STAFF RECOMMENDATION 3612 Richland Avenue Lot 16, Richland Hall Development November 15, 2017

Application: New construction—infill
District: Richland-West End Neighborhood Conservation Zoning Overlay
Council District: 24
Map and Parcel Number: 10409008900
Applicant: Chad Gore, Mike Ford Builders
Project Lead: Jenny Warren, jenny.warren@nashville.gov

Description of Project: Application is to construct a new single family infill home.

Figure 1. Lot at 3612 Richland Avenue

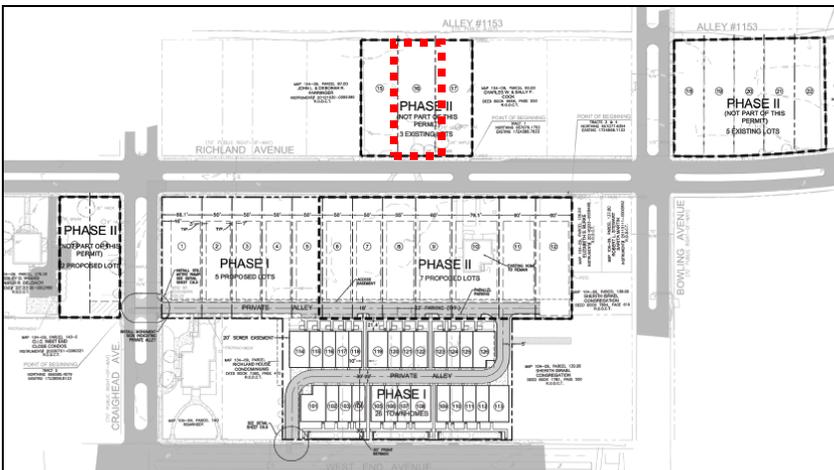
Background: 3612 Richland Avenue is a currently a vacant lot (Figure 1). Formerly on the site was a non-contributing building that was part of the Welch College (formerly the Free Will Baptist Bible College) campus. The College has moved to a new location and the building has been demolished. The new owner of the college’s property plans 22 new infill houses within the Richland-West Neighborhood Conservation Zoning Overlay (Figure 2). To date, MHZC has approved infill and outbuildings for Lots 1, 2, 3, 4, 5, 6, 11, 14 and 17 (3657, 3653, 3649, 3641, 3637, 3633, 3613, 3701 and 3610 Richland Avenue, respectively). Several of these houses have been constructed (See photos at end of document).
